Blue Bird Body Company has determined that a defect, which relates to motor vehicle safety exists in certain 1999 through 2002 model year Blue Bird All American and TC/2000 school and transit buses and Q-Bus and Commercial Series transit buses. Blue Bird is conducting a recall to correct this defect.

The defect involves inconsistent torque on the Hendrickson rear air suspension hanger fasteners and the rear axle torque rod fasteners. Subject buses must be modified according to the attached instructions.

RECALL R01FL INSTRUCTIONS
FASTENER REPLACEMENT ON HENDRICKSON REAR AIR RIDE SUSPENSION

TORQUE ARM FASTENER REPLACEMENT INSTRUCTIONS

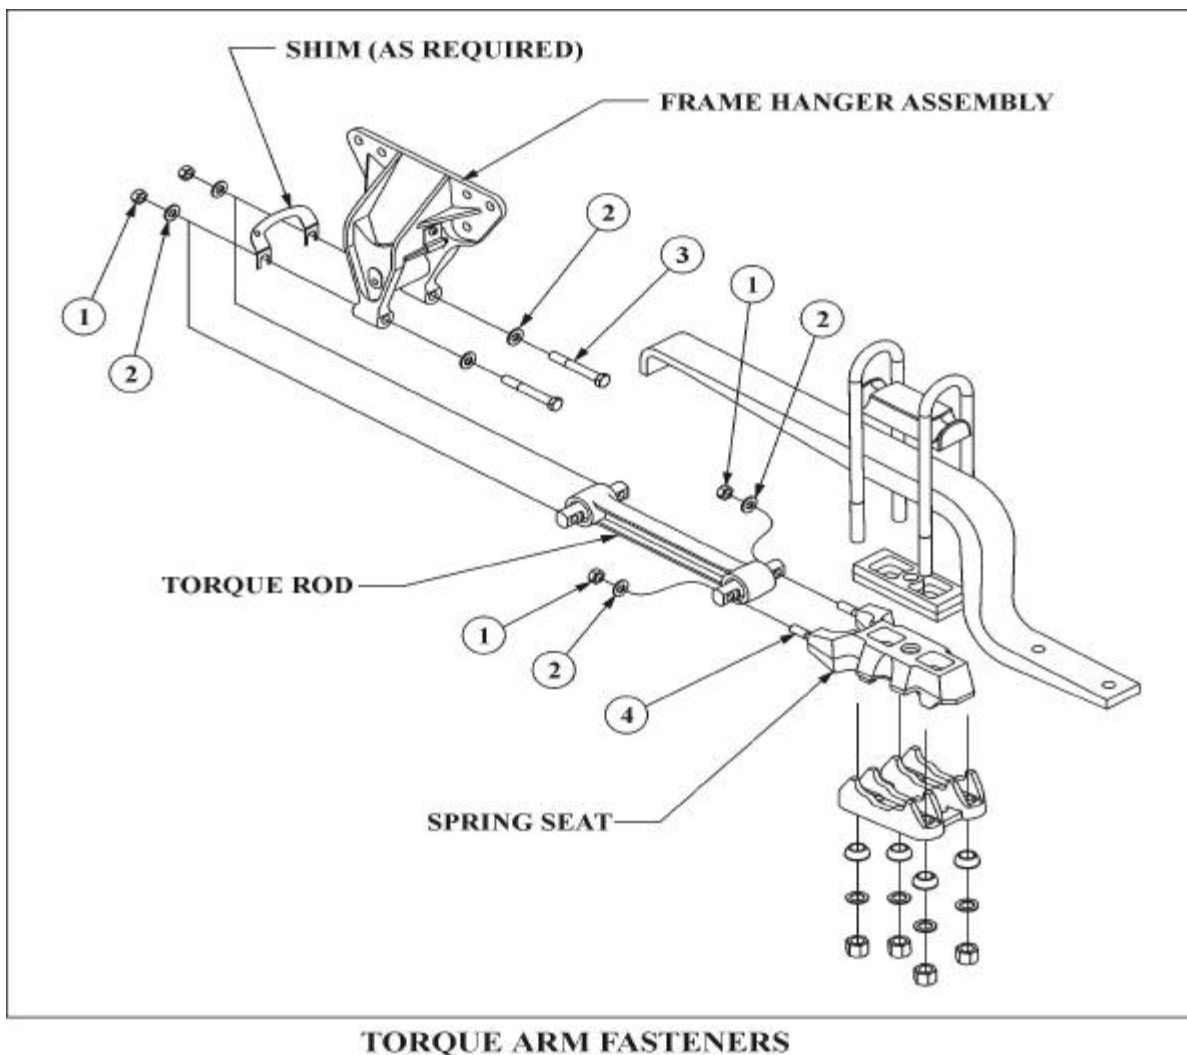
1. On the left side Hendrickson rear air suspension, remove the torque rod fasteners (Items 1, 2, and 3) that attach the torque rod to the frame hanger assembly. See drawing on page 2. Note: If a torque rod shim(s) has been installed, note location, remove and keep. Remove the lock nuts (Item 1) and flat washers (Items 2) that attach the torque rod to the spring seat. Remove and keep torque rod. Discard all fasteners.

2. A kit will be supplied containing the required fasteners for both sides of the suspension. The kit contains twelve (12) 5/8" hardened flat washers, four 5/8"-11 UNC Hex Head bolts 4.5" long, eight 5/8"-11 UNC lock nuts, and four 5/8" studs.

3. Remove and discard the two 5/8" studs (Items 4) in the spring seat bracket and install two new studs by following the instructions on page 11 in **Hendrickson Tech Pub** under **SPRING SEATS** in the **Component Replacement Section**.

NOTE: If either stud is broken and cannot be removed, replace existing seat with a new spring seat from Blue Bird before installing new locknuts and hardened flat washers. See "**INSTRUCTIONS FOR REPLACING SEAT**". Contact Bill Coleman at 478-822-2242 for a replacement spring seat.

4. Install torque rod onto spring seat studs. Install two new 5/8" hardened flat washers (Item 2) and two new lock nuts (Item 1) onto spring studs. Hand tighten locknuts.

5. Position torque rod against frame hanger assembly. Install two 5/8" torque rod bolts (Item 3) and two hardened flat washers (Item 2). Install two lock nuts (Item 1) and two flat washers (2) onto bolts. If a torque rod shim(s) had been removed, re-install in the same position as originally installed. Torque these bolts and the locknuts for the spring seat studs to 150-205 ft. lbs.
6. Repeat above procedure on right side of Hendrickson rear air suspension.

INSTRUCTIONS FOR REPLACING SPRING SEAT (IF REQUIRED)

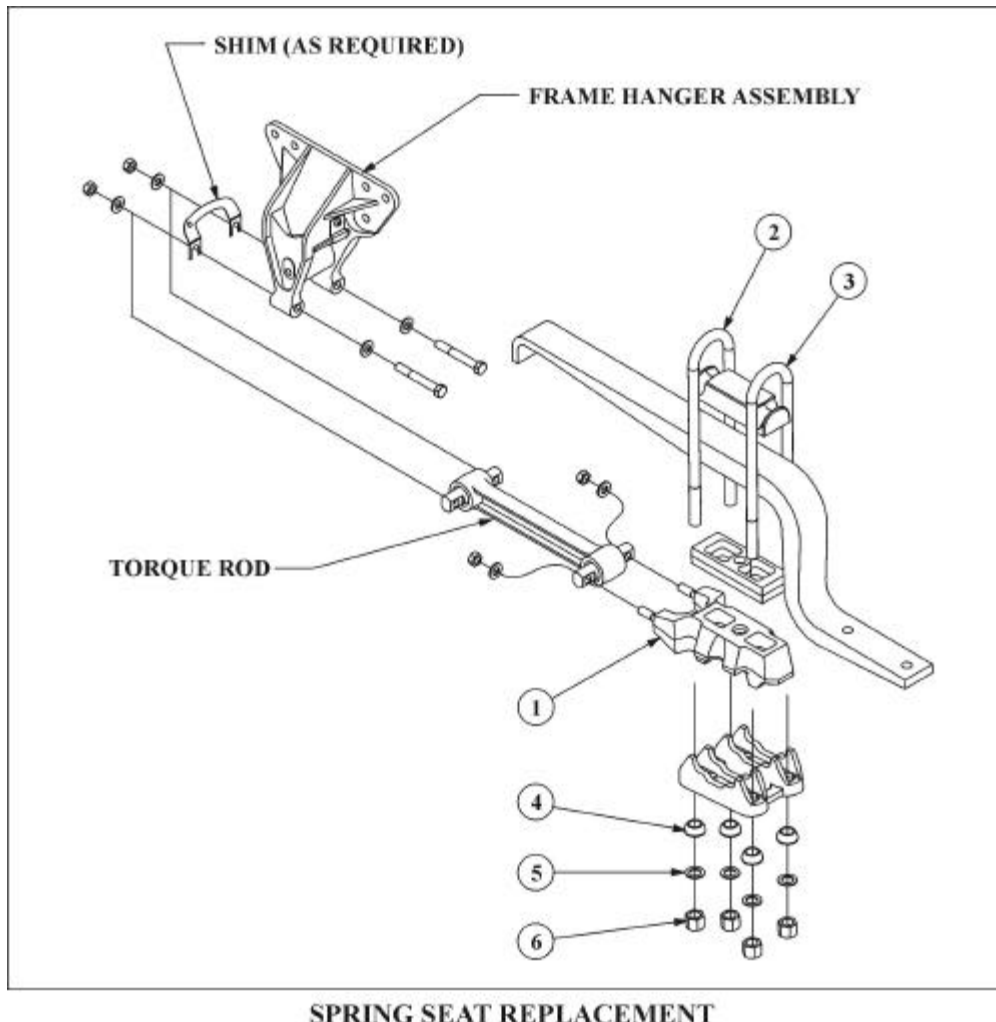
Contact Bill Coleman at Blue Bird at 478-822-2242 for the correct spring seat (Item 1).

Note: Provide Bill Coleman with Blue Bird body number for the vehicle along with the Hendrickson part number, if legible. Hendrickson part number is painted across the spring seat. (Reference **Hendrickson Tech Pub** page 11 figure 13)

1. New u-bolts (Items 2 and 3), spherical washers (Item 4), flat washers (Item 5), and u-bolt nuts (Item 6) will be supplied with a new spring seat (Item 1). Discard all removed u-bolts, washers and nuts. **DO NOT REUSE**.
2. Follow the instructions in **Hendrickson Tech Pub** under **SPRING SEATS** in the **Component Replacement Section** page 11 for spring seat replacement and installation of new U-bolts. Torque per instructions found on the back page of **Hendrickson Tech Pub**.
3. Recommend that the drive axle alignment be checked after replacing spring seat. Rear axle alignment specifications are 0 to ¼” of center using laser alignment equipment.

FRAME HANGER ASSEMBLY BOLT REPLACEMENT

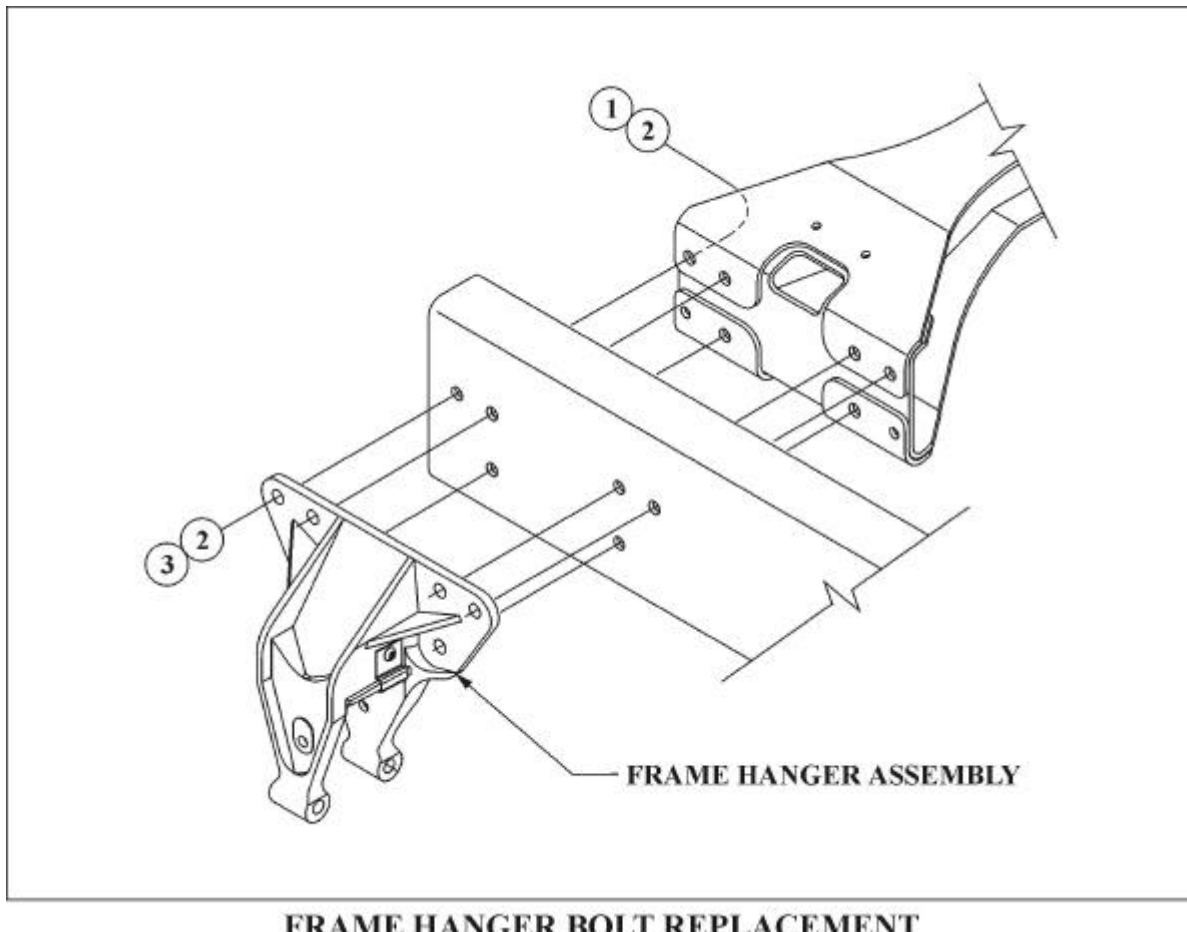
Caution: Wires and tubing may need to be moved to reach bolt heads with socket. Take the necessary steps to protect all wiring and tubing.

1. On the rear suspension left frame hanger assembly (it is recommended to replace two bolts at the time), remove and discard the six 5/8" bolts (Item 1), twelve hardened flat washers (Item 2), and six 5/8" locknuts (Item 3) shown in the illustration. Install six new 5/8" Class L9 bolts (Item 1), twelve Class L9 washers (Item 2), and six Class L9 locknuts (Item 3). Torque (by nut) to 205-ft. lbs.
2. Repeat on right frame hanger assembly.
